UNITED STATES PATENT AND TRADEMARK OFFICE

Office Action Summary	Application No. 10/598,287	Applicant(s) FLETT ET AL.	
	Examiner Larry E. Waggle, Jr	Art Unit 3775

DETAILED ACTION

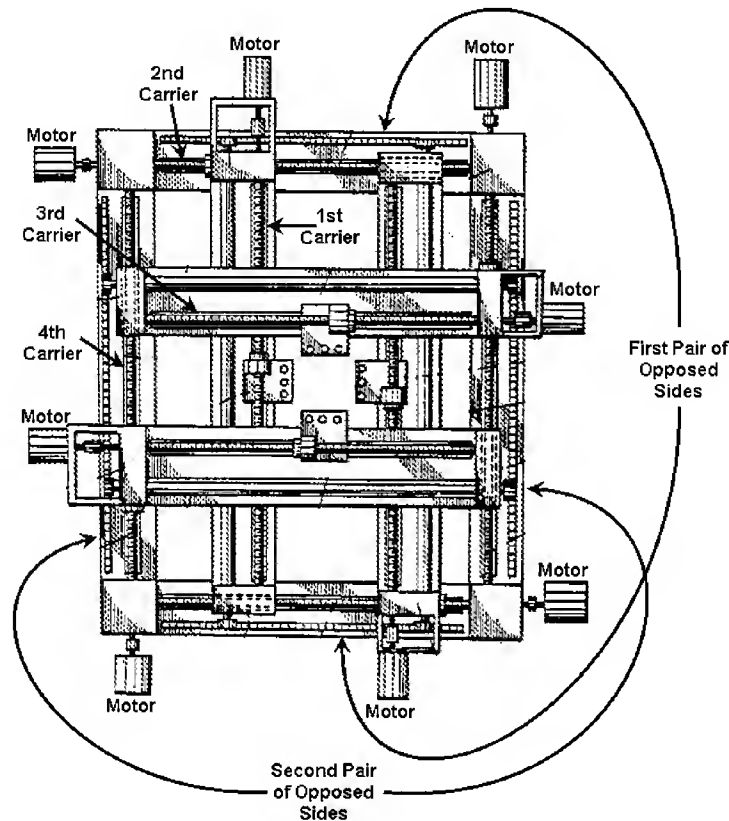
Yanagisawa '790' discloses a jig (Figure 6) comprising a support frame (320); a first guide member (302) mounted on the support frame via a first arm (i.e. element connecting 306 and 318) and translatable (i.e. by drive mechanisms / 1st and 2nd carriers / lead screw) over a first plane (i.e. defined by movement of 302 in both the X and Y directions); and a second guide element (324) mounted on the support frame via a second arm (i.e. element connecting 328 and 340) and translatable (i.e. by drive mechanisms / 3rd and 4th carriers / lead screw) over a second plane (i.e. i.e. defined by movement of 324 in both the X and Y directions) parallel to the first plane, wherein each guide element is independently driven by an electric motor (i.e. similar to 8b in Figure 1)

and the support includes a first pair of opposed sides, each including a slider (306 and 318), and a second pair of opposed sides perpendicular to the first pair, each including a slider (328 and 340) (see annotated Figure below and column 9, lines 7-45).
